OYSTER CREEK NUCLEAR GENERATING STATION

Technical Specification Change Request No. 243

Oyster Creek Nuclear Generating Station (OCNGS)
Operating License No. DPR-16
Docket No. 50-219
Technical Specification Change Request No. 243

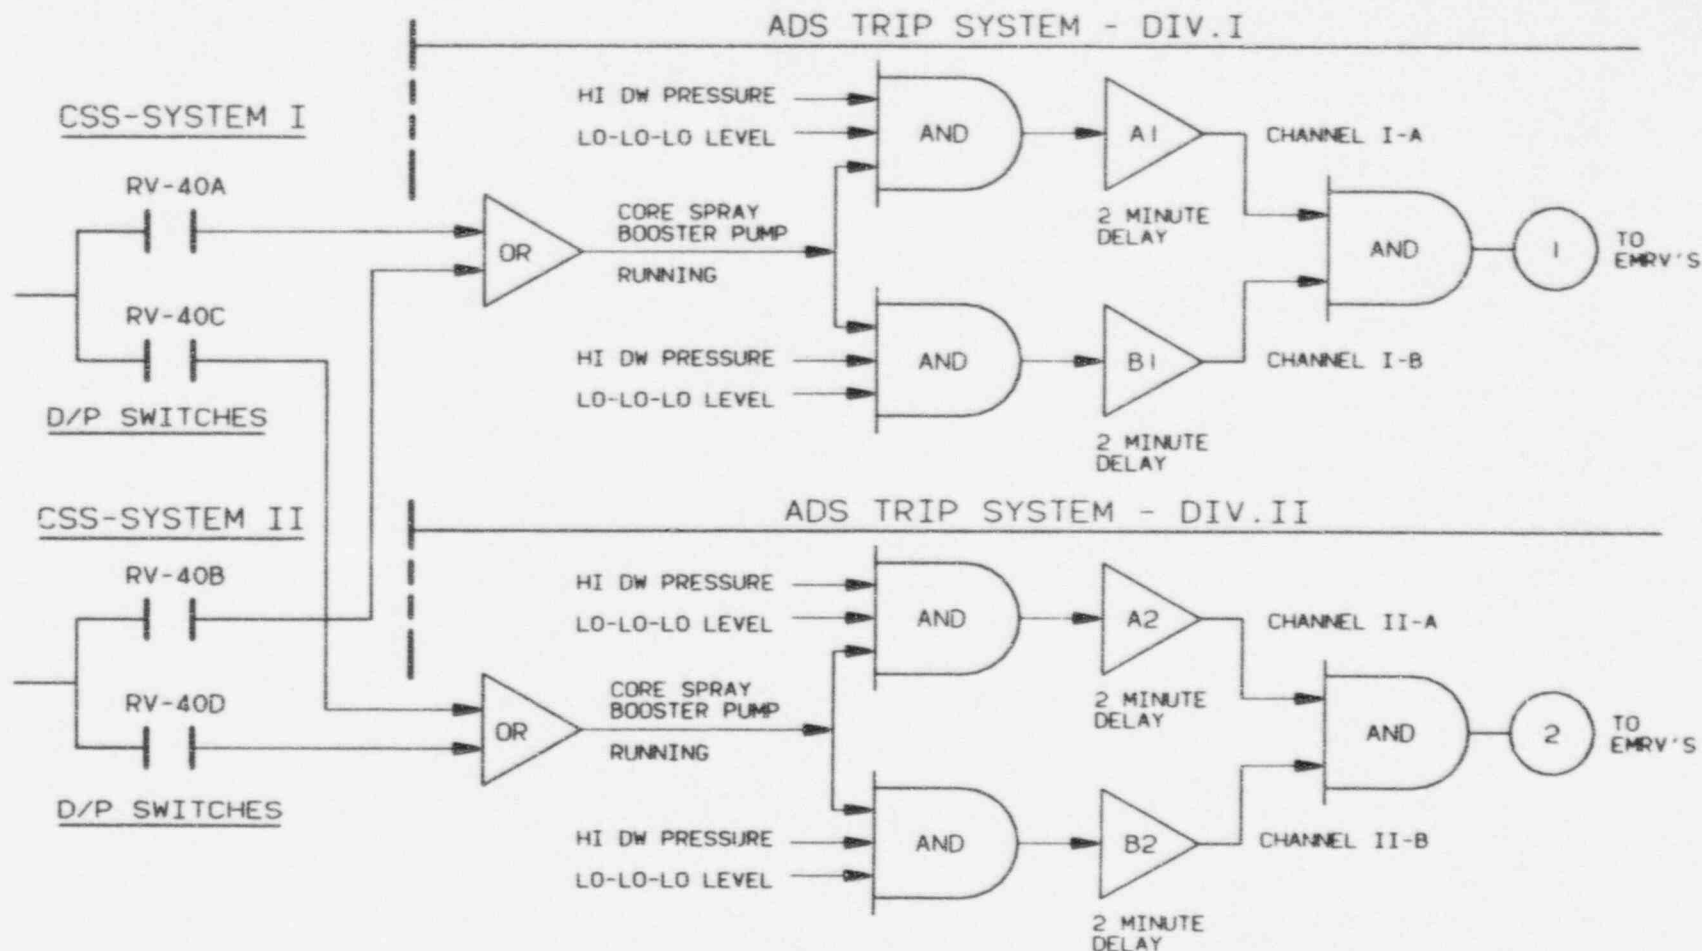
- A. CSS I PHYSICALLY CONTAINS THE CORE SPRAY BOOSTER PUMP d/p SWITCHES : RV-40A AND RV-40C.
 - B. CSS II PHYSICALLY CONTAINS THE CORE SPRAY BOOSTER PUMP d/p SWITCHES : RV-40B AND RV-40D.
- EACH CSS BOOSTER PUMP d/p SWITCH MONITORS BOTH CORE SPRAY BOOSTER PUMPS IN ITS RESPECTIVE SYSTEM.

1. DIV. I UTILIZES SIGNALS FROM EITHER RV-40A OR RV-40B TO DETERMINE THAT A CORE SPRAY SYSTEM IS OPERABLE, THUS PROVIDING THE "INTERLOCK" PERMISSIVE FOR ADS ACTUATION OF THE EMRV'S.
2. DIV. II UTILIZES SIGNALS FROM RV-40C OR RV-40D TO PROVIDE THE CSS "INTERLOCK" PERMISSIVE.
3. EACH OF THE TWO CHANNELS IN AN ADS TRIP SYSTEM DIVISION ARE REQUIRED FOR THE ADS ACTUATION OF ALL (5) EMRV'S, AS SHOWN.
4. EACH ADS TRIP SYSTEM IS REDUNDANT TO ITS COUNTER PART, THE INITIATION SIGNALS, HI DW PRESS. & LO-LO-LO REACTOR LEVEL ARE 2/2 TAKEN TWICE; AND, CS BOOSTER PUMP d/p INTERLOCK PERMISSIVE IS 1/2 TAKEN TWICE.
